IDA PAPER P-3016

INDEPENDENT REVIEW OF THE DEVELOPMENT RISKS ASSOCIATED WITH THE COMANCHE ARMED RECONNAISSANCE HELICOPTER

August 1994

Prepared for
Director, Tactical Warfare Programs

EXISTING CONTRACTED DEVELOPMENT PROGRAM

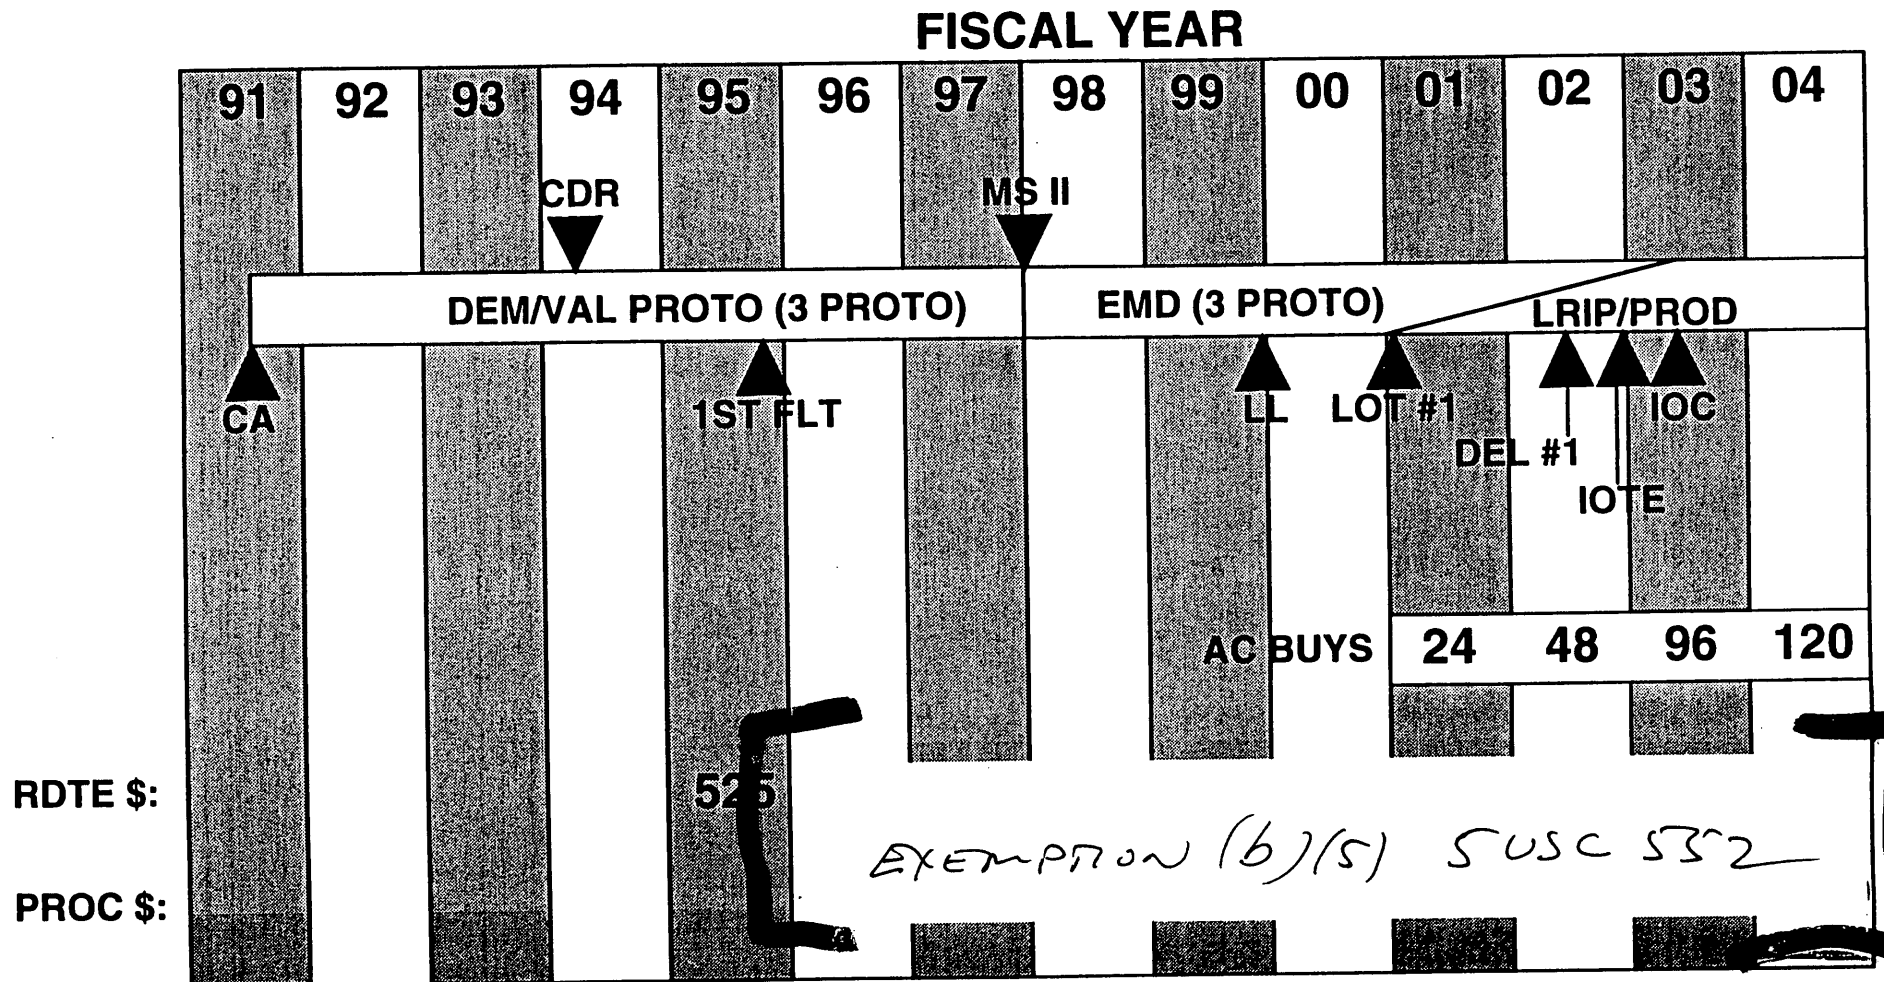
This chart shows the schedule and funding profile for the existing, contracted COMANCHE development program. Actually, only the DEM/VAL phase is currently under contract. If this development plan were continued, the Army's COMANCHE Program Office and the Boeing-Sikorsky Joint Program would soon need to begin negotiating a contract for the EMD phase of development.

As indicated on the schedule, this program features three prototype aircraft built and tested during the DEM/VAL phase, with first flight of the first COMANCHE prototype scheduled for November 1995. Three additional prototypes would be built and tested during the EMD phase. At the conclusion of DEM/VAL and prior to the award of the EMD contract, a Milestone II review would be held for the program. Long-lead production would begin at the end of FY 1999 and the first 24 production aircraft would be funded in FY 2001. Plans call for production to ramp up to 48 in FY 2002, to 96 in FY 2003, and to the full production rate of 120 per year by FY 2004. The first production aircraft would be delivered to the Army in mid FY 2002. The Initial Operational Test and Evaluation (IOTE) would be held early in FY 2003. Initial Operating Capability would be achieved by mid FY 2003.

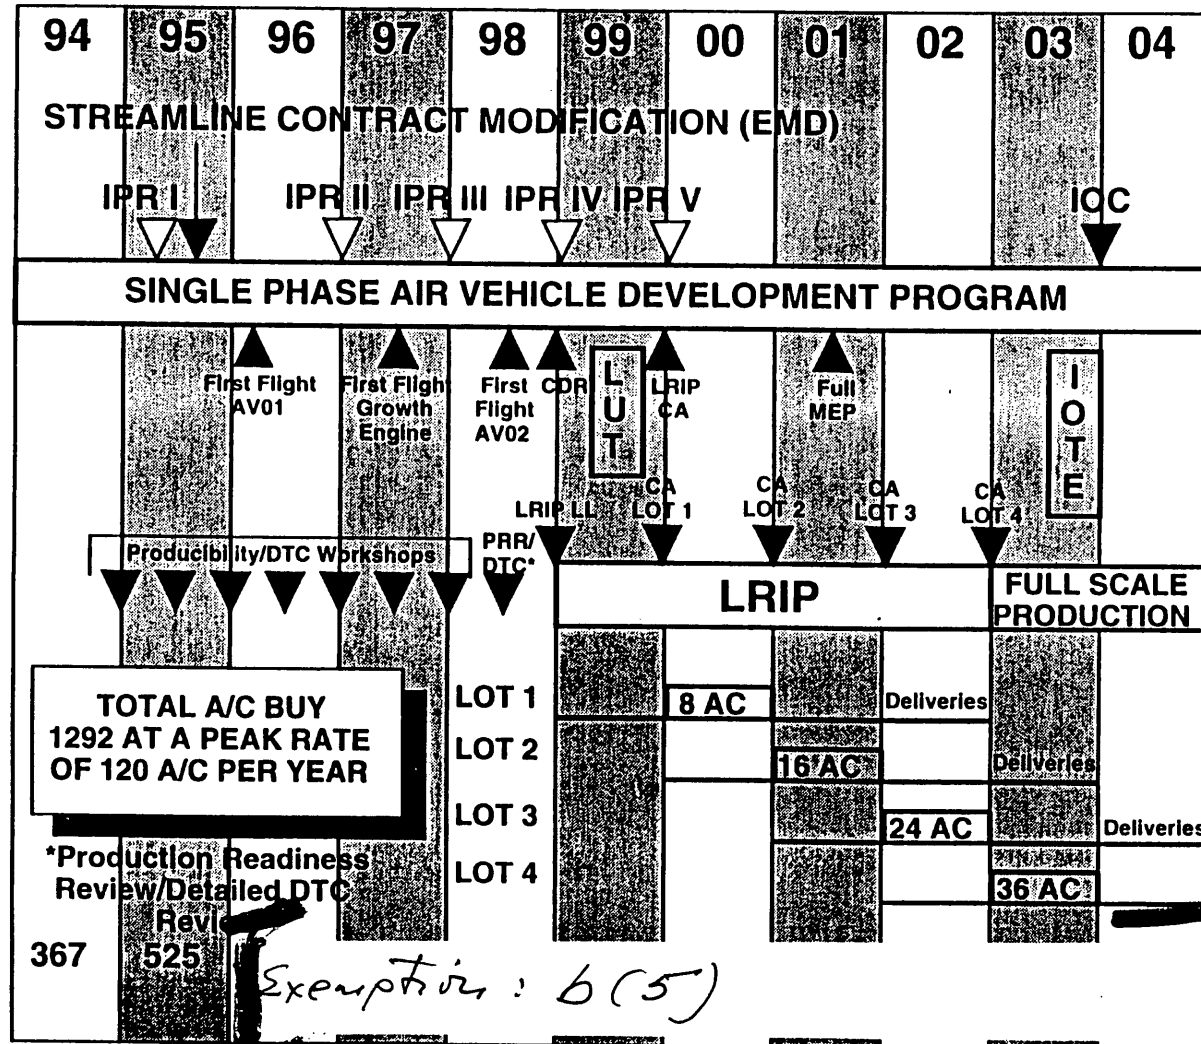
The schedule for the "streamlined" development program proposed by the Army is shown on this chart. Under this plan, in May 1995 the Army would modify the existing COMANCHE development contract to incorporate the activities normally conducted during EMD into a new single-phase development program. The first flight of the first of two DEM/VAL prototypes would occur in early FY 1996, several months later than was proposed under the existing development contract. The first flight of the second DEM/VAL prototype would not occur until late FY 1998, nearly 2 1/2 years after the first flight of the first prototype. The next three prototypes would be taken from the first lot of eight Low-Rate Initial Production (LRIP) aircraft. These prototypes would be delivered to the Army during FY 2002.

In comparison to the Army's previous plan for COMANCHE development, the "streamlined" plan initiates production one year earlier, but at a significantly slower rate. In the first year (FY 2000), only 8 aircraft would be built; in the second, 16 aircraft; in the third, 24 aircraft; and in the fourth (FY 2003), 36 aircraft.

OSD oversight for this program would be accomplished through a series of In-Process Reviews (IPRs), the first of which would occur early in FY 1995 prior to the award of the modified development contract. Beginning at the end of FY 1996, in-process reviews would

be scheduled annually to enable OSD to track program development.

Finally, as indicated on the chart, the funding profile for the proposed "streamlined" program is the same as is currently planned for the existing program.

REVISED STREAMLINED PROGRAM

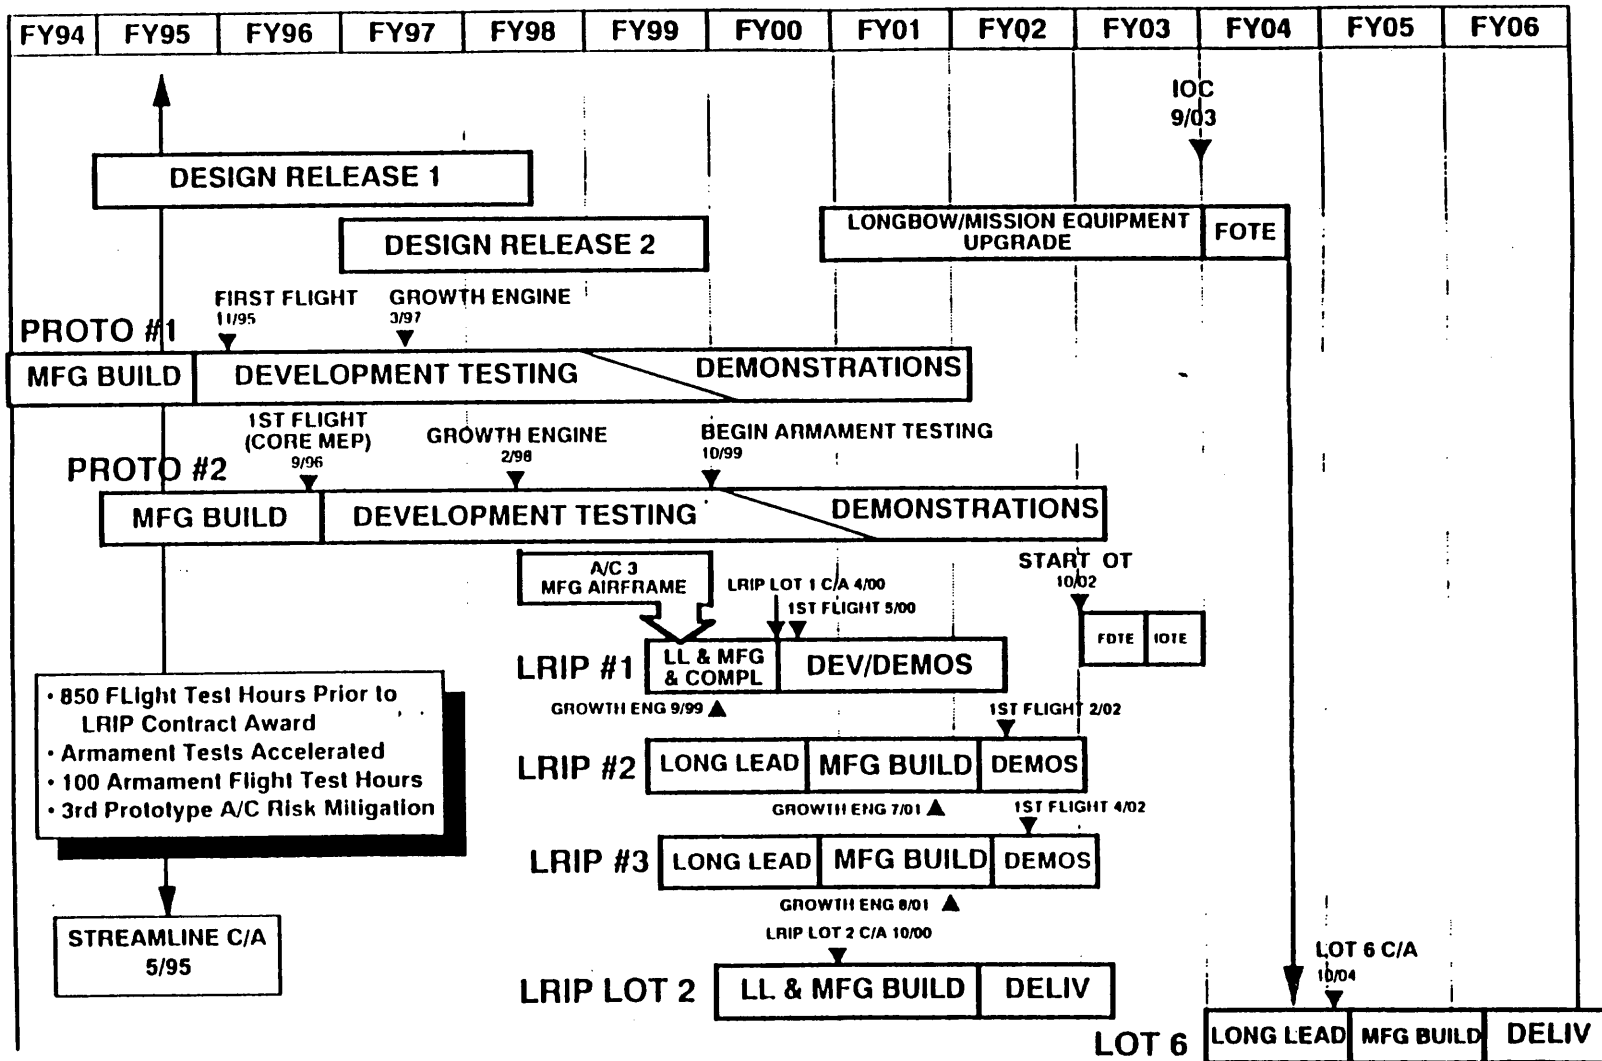
Following the submission of its original "streamlined" proposal, the Army's COMANCHE Program Office significantly revised its approach, in large part to remedy deficiencies identified during the OSD review of the plan as well as objections raised in other critiques, including that of this panel. This chart shows the revised "streamlined" program as briefed to the review panel on August 18, 1994. Relative to the initial "streamlined" approach, the revised approach features a number of significant changes of which the principal alterations are summarized on the next two charts.
